ADDENDUM NO. 1

PROJECT: MSBA Accelerated Repair Program
Window & Door Replacement Project
Lincoln-Hancock Community School
Quincy, Massachusetts
RBA Project No. 2014071

DATE: January 20, 2015

CLARIFICATION OF DOOR SIZES WITHIN CURTAINWALLS

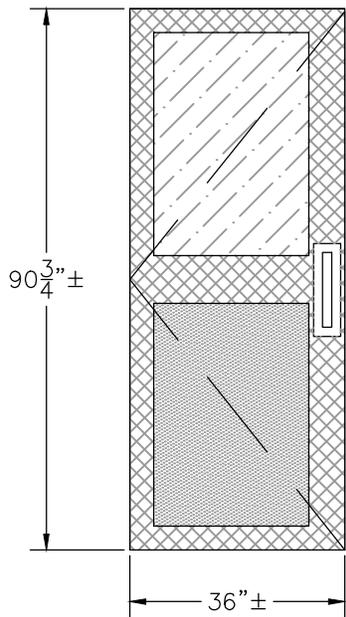
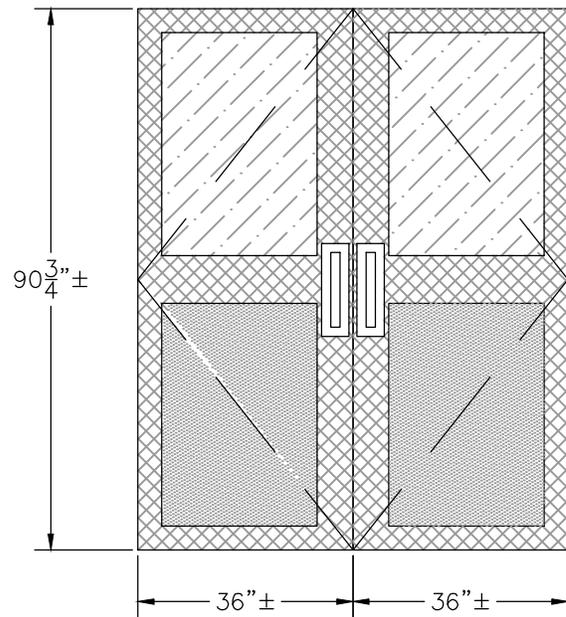
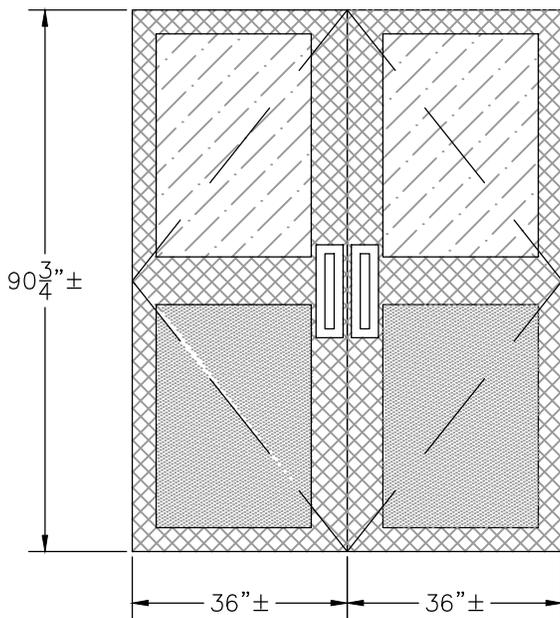
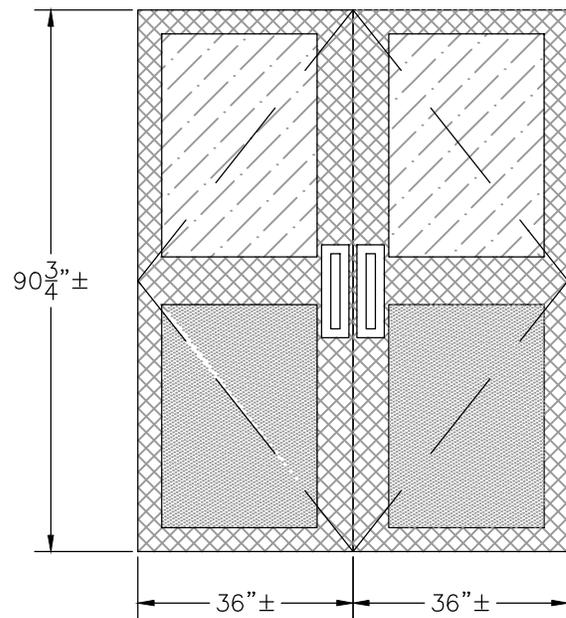
Item No. 1 Bidder Question: Dwg A8.4 shows only door schedule for entrances. There is no door schedule of the doors inserted in the Curtain Walls (A8.0 & A8.1). Please clarify dimensions, details and types for these doors (E5, E7, E8, E12).

Response to Item No. 1: Sheet A8.4 (Door Schedule) has a note directing towards the Curtain Wall drawings for additional doors. Sheet Sk-1 (attached) is to be used for clarification of the door dimensions requested (E5, E7, E8, E12). The details shown on the Curtain Wall Drawings are to be used for these doors.

CURTAINWALL JAMB W/ REMOVAL OF EXISTING STEEL FRAME

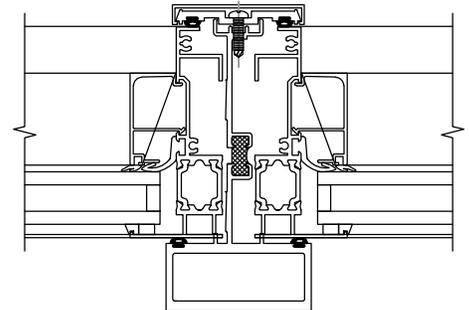
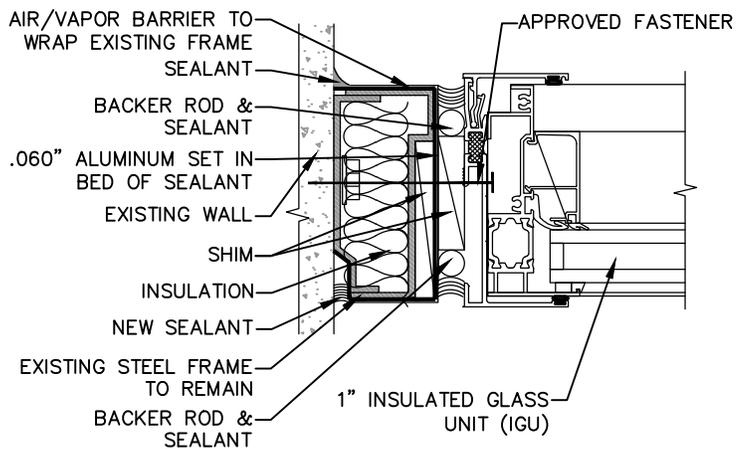
Item No. 5 Bidder Question: During the walk-through there was a question raised about what part of the existing steel frame would remain and whether it would be acceptable to remove the entire existing steel frame in place of removing only a portion of the existing frame.

Response to Item No. 5: The head to the existing steel frame must remain as shown in the details. The existing steel frame is attached via clips and steel angles to existing steel beams, which are located above the ceiling and will not be accessible. The existing steel frame at the head will be needed for fastening of the new aluminum framing. However, the existing steel frame will be allowed to be removed (at the choice of the bidder) from the jamb locations as shown on sheet SK-2 (attached). The steel frame must be removed from the sills as originally shown in the drawing set dated 01.07.15.

NO	DATE	BY	DESCRIPTION
1	01.20.15	RCO	MULLION REMOVED FROM DRAWING

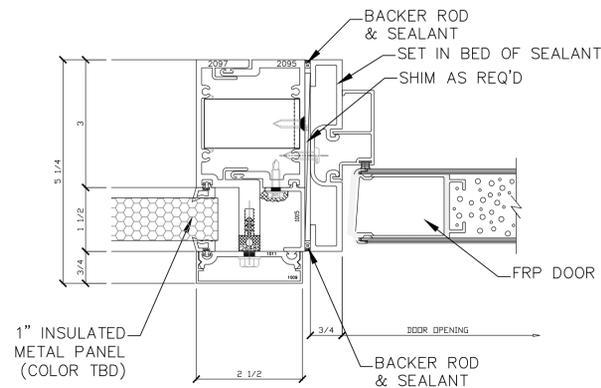
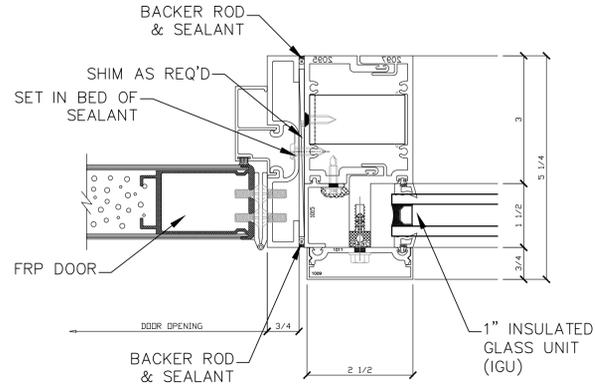
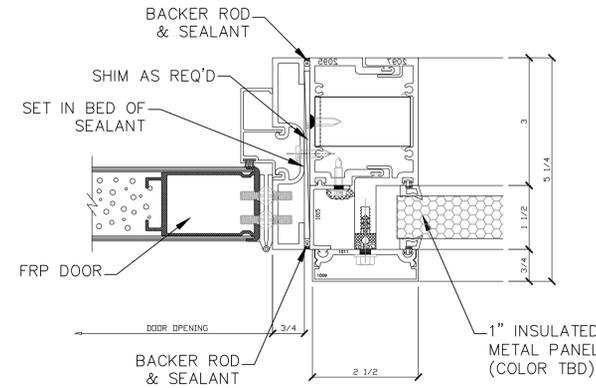
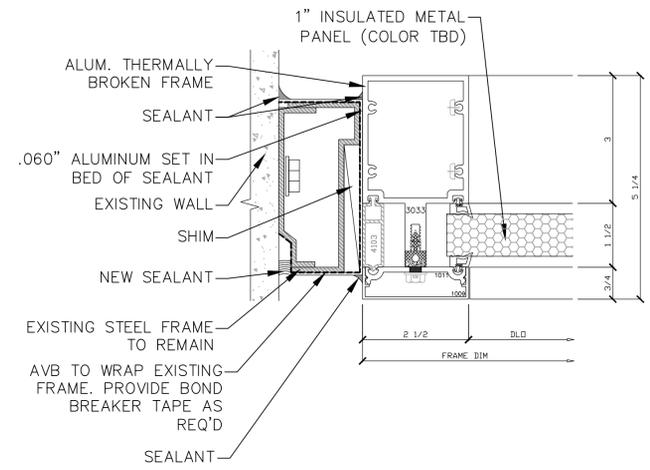
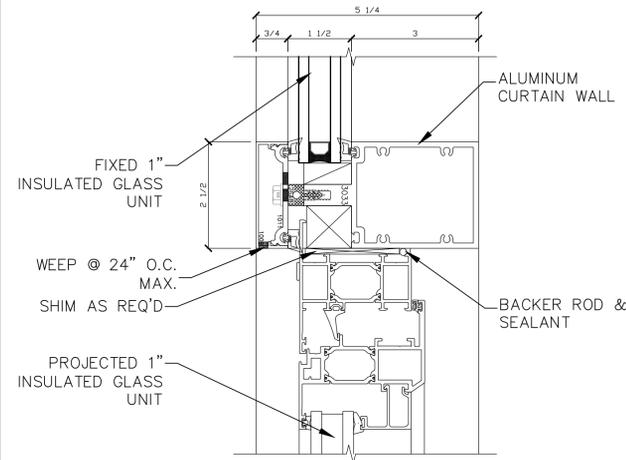
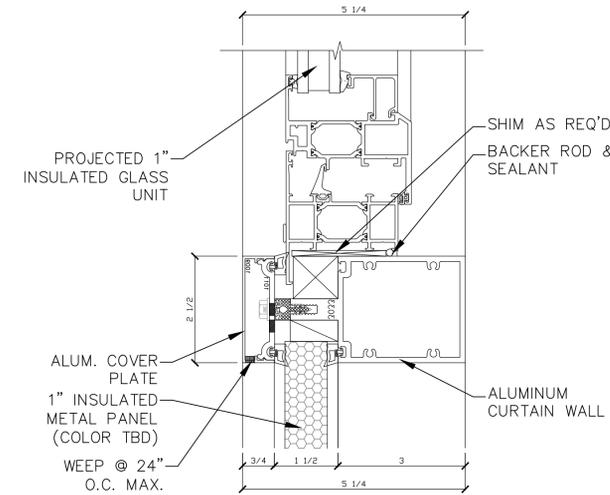
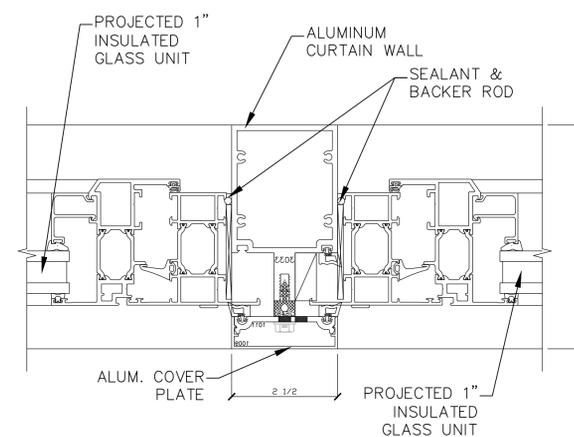
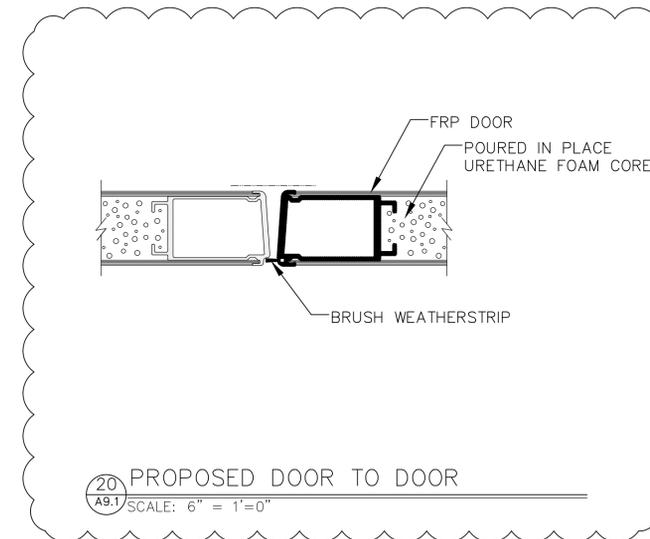
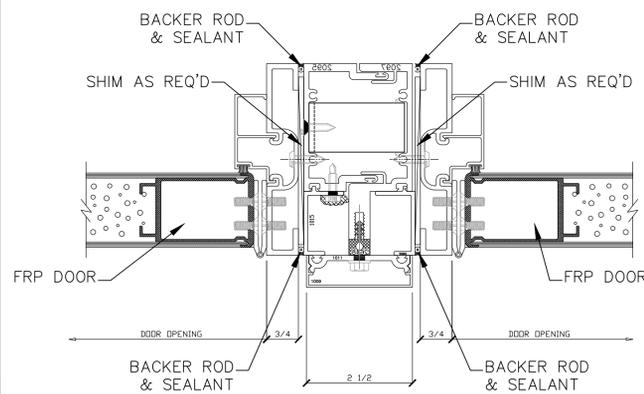
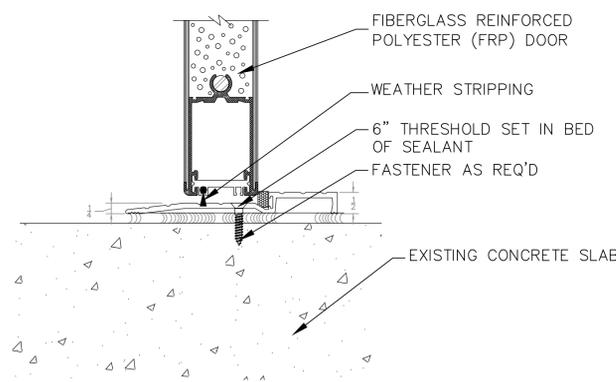
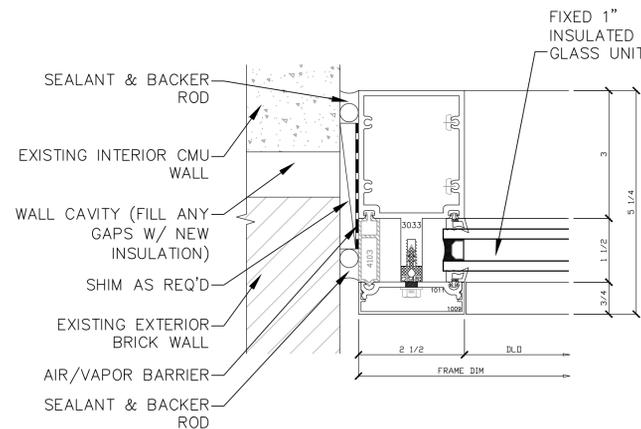
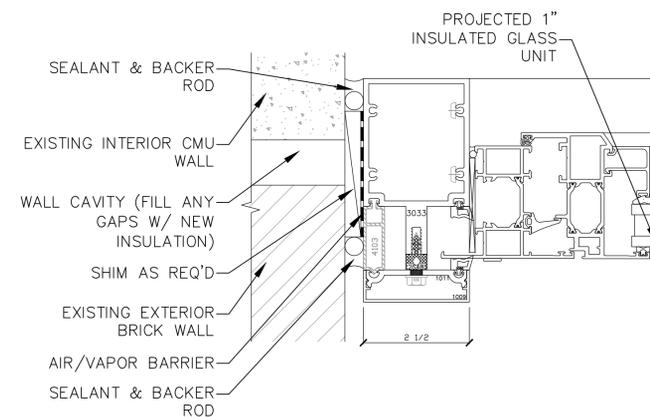
- 1. Add drawings SK-1, SK-2 and SK-3, attached.
- 2. Substitute Drawing A9.1 (Addendum No. 1) attached.
